**PROPOSED DEVELOPMENT AT  
135 GUISBOROUGH ROAD,  
NUNTHORPE**

**APPRAISAL OF DEVELOPER'S  
AMENDED PROPOSALS**

**PLANNING REF: M/FP/0770/07/P**

**15 JUNE 2007**

**APPRAISAL OF DEVELOPER'S AMENDED PROPOSALS**  
 SKETCH 1  
 GEOMETRIC DESIGN PARAMETERS

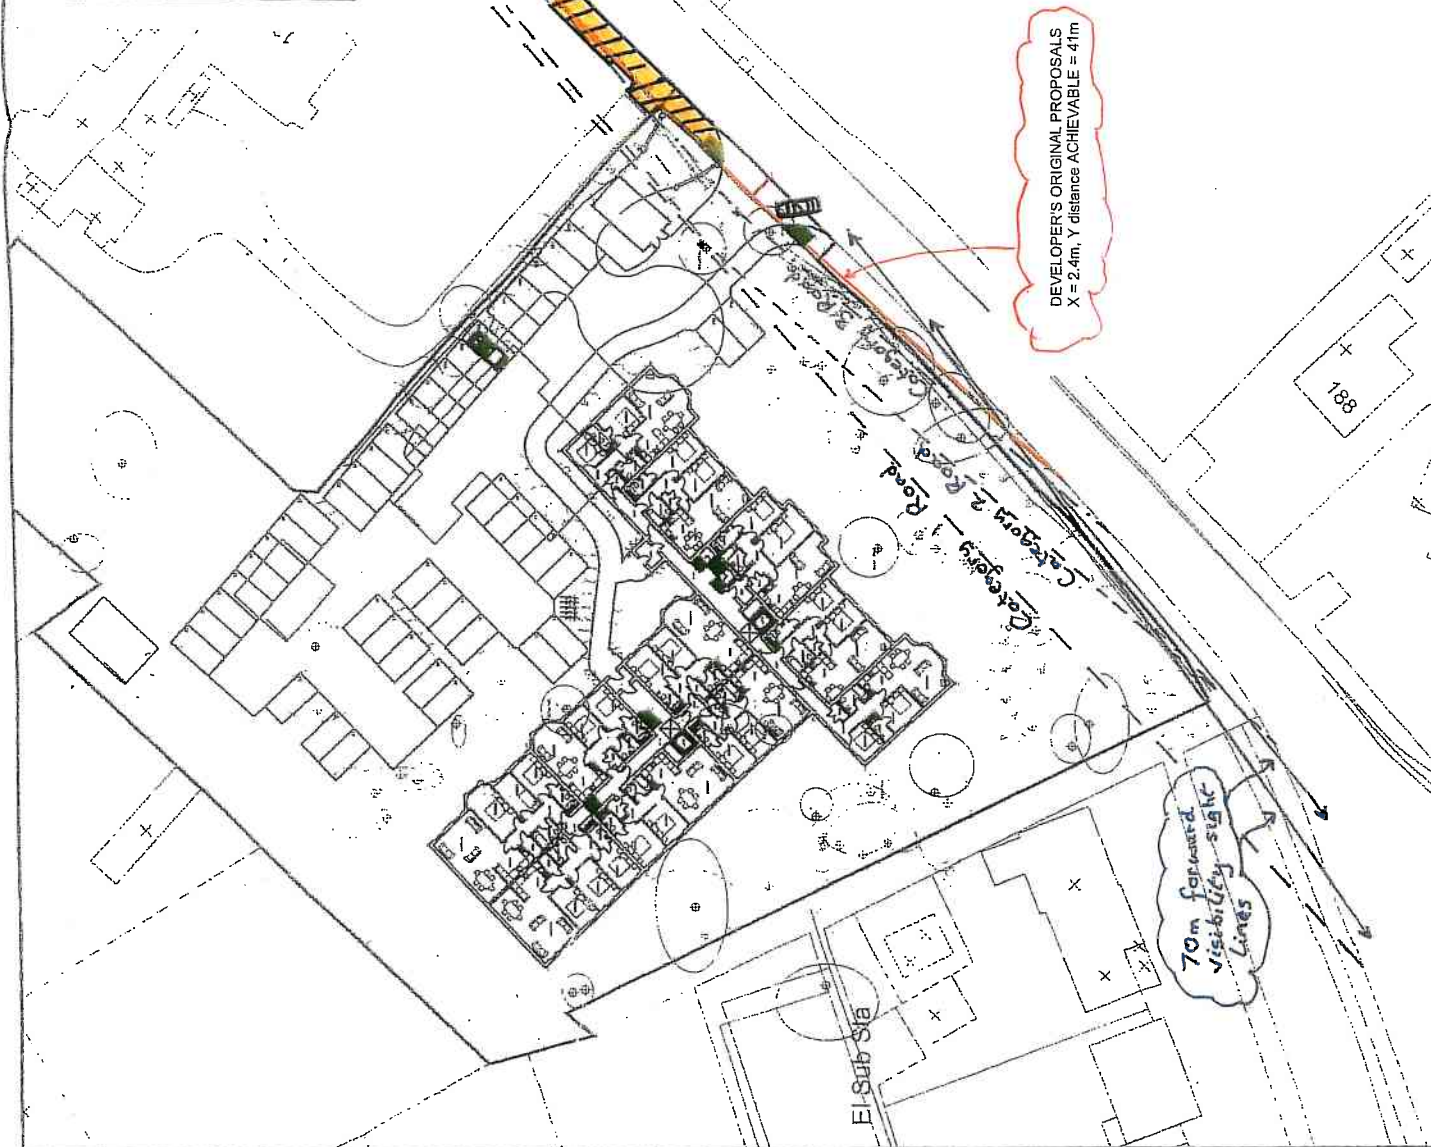
- The limits of the adopted highway are interpreted by the Developer from information provided by the Council and are transferred to a drawing of such a small scale, that its validity in respect of exact location and area covered is highly questionable. The submitted information cannot be relied upon in any reasonable assessment (see Sketch 1).

An assessment 'on site' and an assessment of Wardell Armstrong's proposals indicate that, although the proposed access has been amended, the forward visibility of vehicles turning into or out of the access, for drivers travelling from west to east, falls beneath the 70m distance advocated by Wardell Armstrong, (see sketch), and beneath the desirable minimum distance of 90m required by DMRB.

**SKETCH 2**

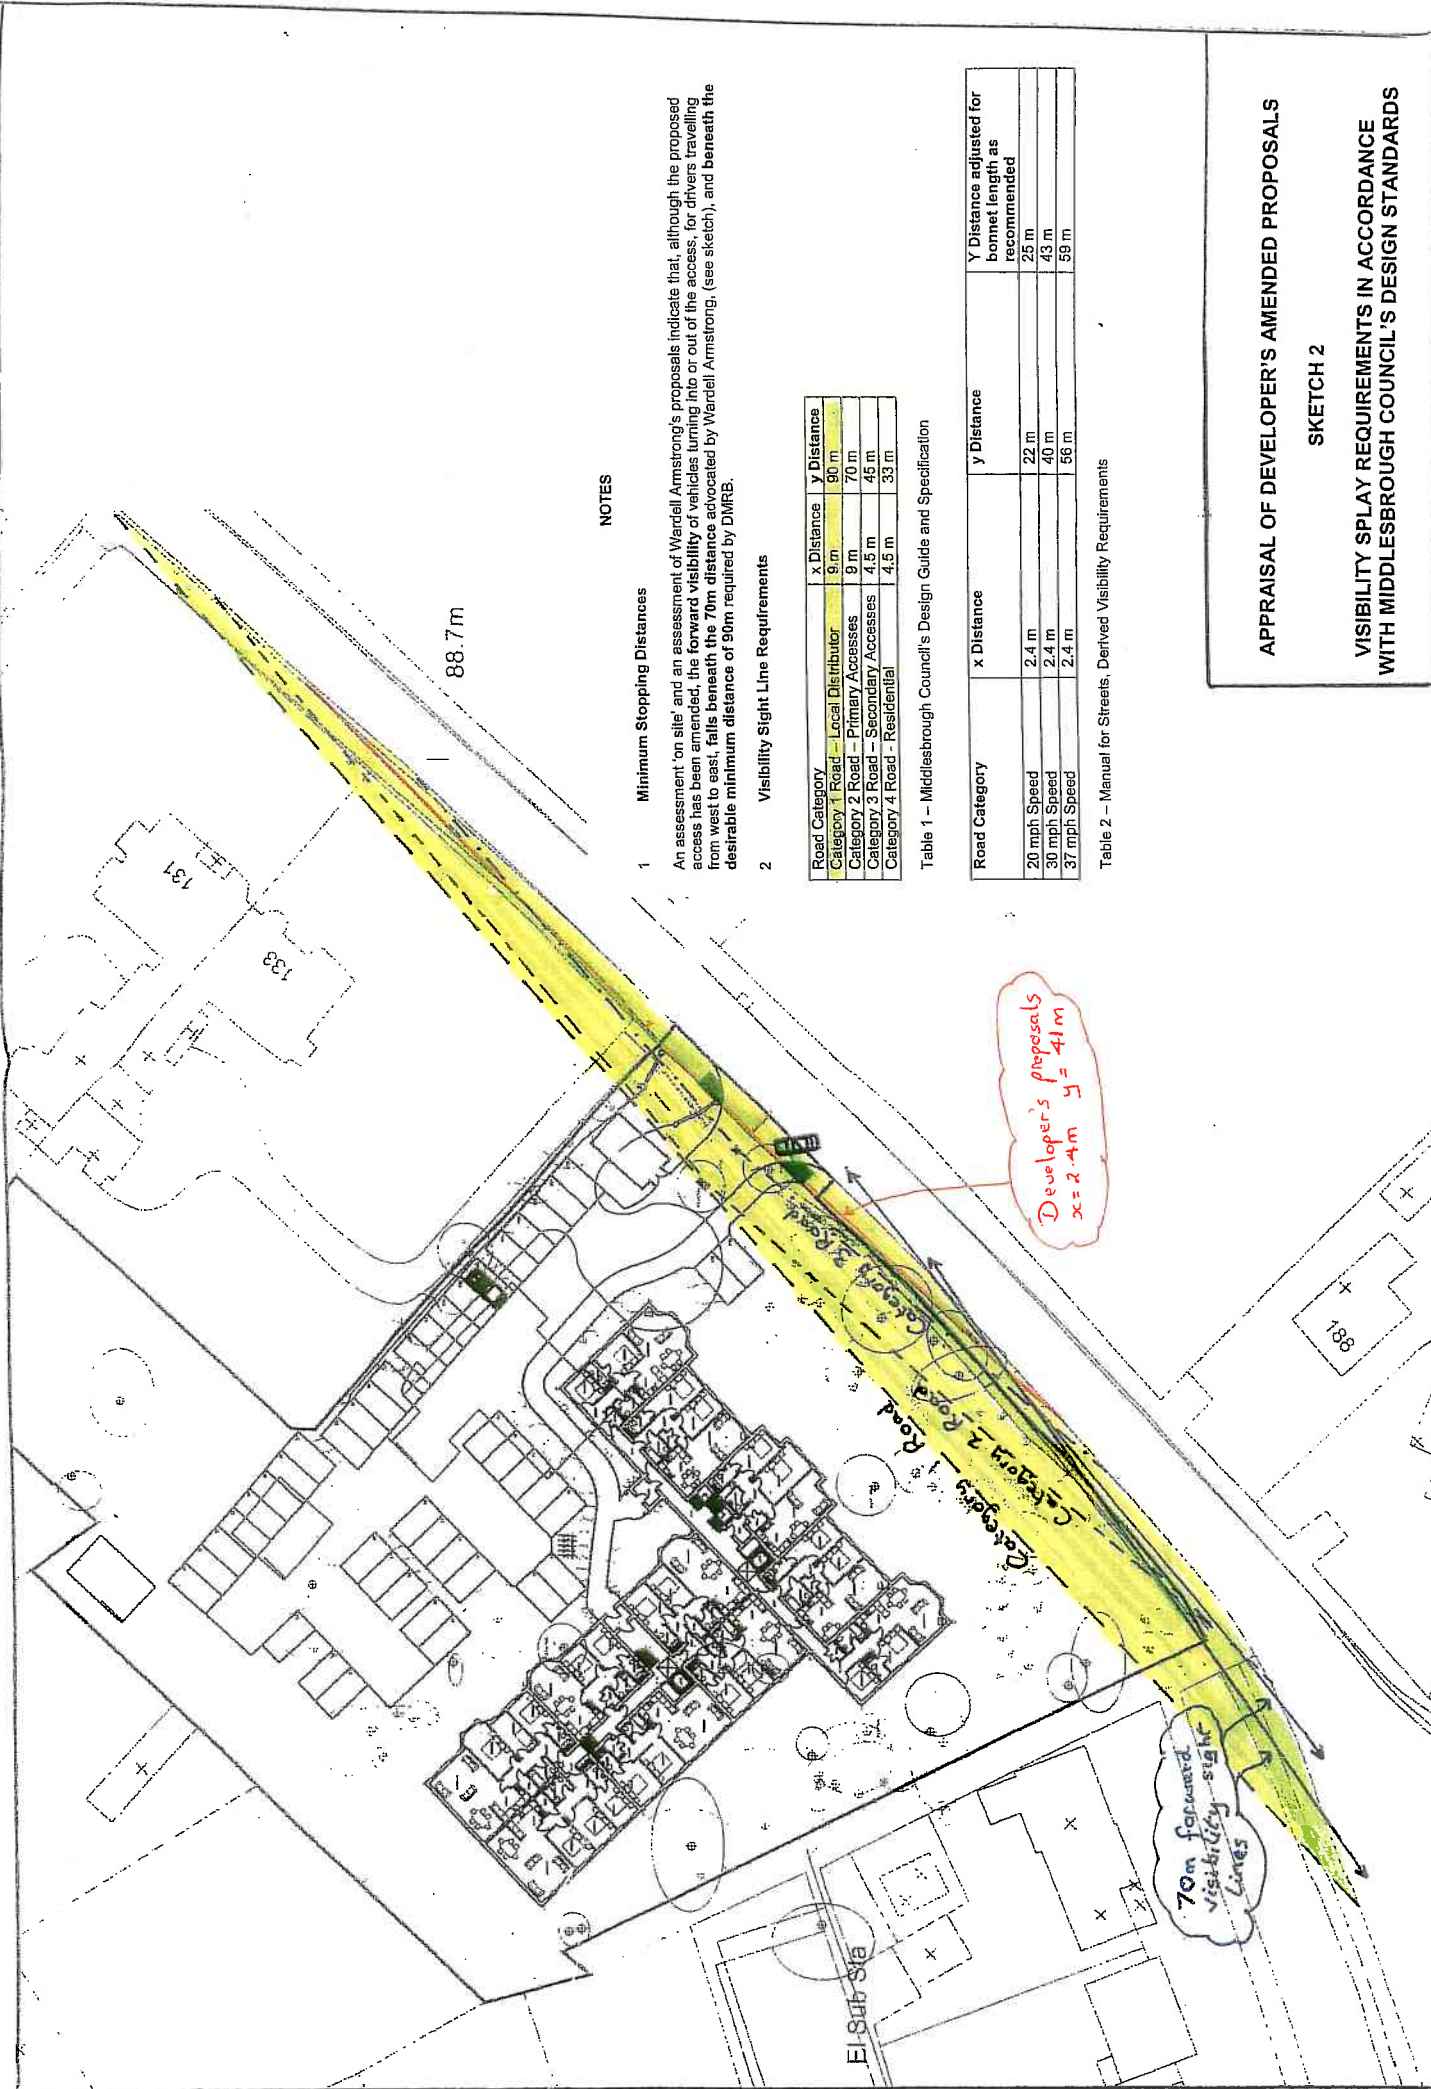
- The DIA demonstrates that the appropriate design standard in this instance is Middlesbrough Council's own 'Design Guide and Specification', This requires visibility distances of  $x = 9\text{m}$  and  $y = 90\text{m}$ . **The Developer's proposals fail to meet these standards.**

- In addition, Sketch 2 clearly shows the substantial land-take that will be required to accommodate these values. This includes significant areas of privately owned land, not in the control of the Developer and outside of adopted highway.
